EASTERN TECHNOLOGIES, INC.

SUBJECT: ETI Procedures

Responses to Questions

Drawing No. PF001 Revision 2

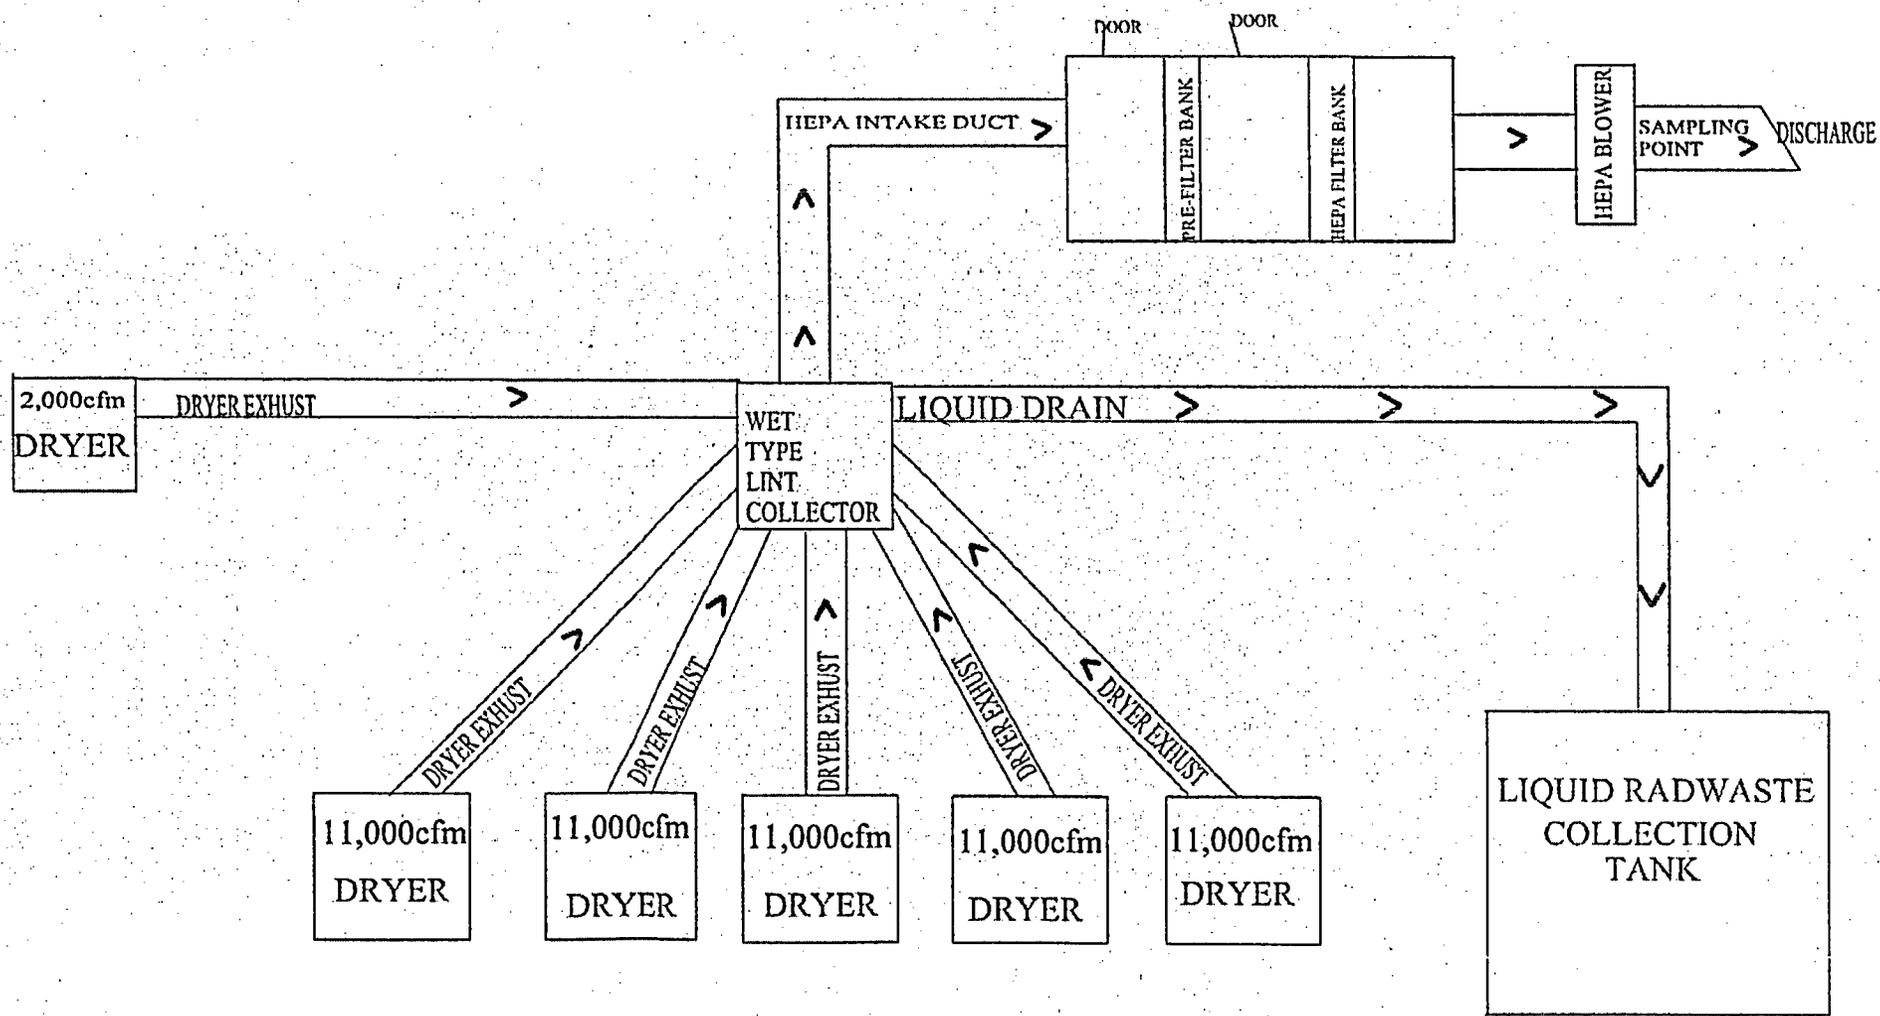
6. Applicable drawings have been revised to detail the general location for air sample collection points, both breathing air and environmental

release. Breathing air sample collection points will be situated to ensure representative sampling of personnel's breathing air. Air sample points for environmental releases will be down stream of blowers to ensure proper mixing of filtered air prior to sampling. Drawing No. PF 004 has been revised to include manufacturer detailed air flow rates. Drawing No. PF 004 currently notes location of the sampling points. Drawing No's. PF 001, PF 002, & PF 003 have been revised to detail four (4) holding tanks.

8. The size and placement of the HP Lab (counting laboratory) can be reviewed on drawing No's PF 001 and PF 002. The lab will be shielded to reduce interference from elevated background radiation caused by materials undergoing processing. Enclosed are print outs containing specific performance information relative to counting equipment that will be used in the lab. This equipment is also detailed in section 8.10.2 of our application. As these systems have not yet been purchased calibration procedures are not yet available. Applicable procedures can be supplied prior to pre-operational inspections performed by NRC. All counting equipment will be calibrated in accordance with manufacturer's instructions or returned to the manufacturer for calibration. It should be noted that ETI reserves the right to substitute or upgrade this equipment as needed. It should also be noted that ETI does not consider lab analysis of wipe samples (smears) necessary to determine applicable radiological conditions associated with a particular sample. Analysis of such wipes (smears) with a calibrated hand held radiation detection device should be sufficient to generate the information needed. This is not to say that stationary lab counting equipment will not be used for such purposes, it may be used but ETI wishes to reserve the right to utilize other equipment capable of performing the required counting analysis. With regard to analysis of wastewater samples ETI will use gamma spectroscopy to determine the types and concentrations of isotopes present. Performance information for such a system is enclosed for your review. The system that ETI utilizes will meet or exceed the performance parameters detailed in this print out. As with other systems
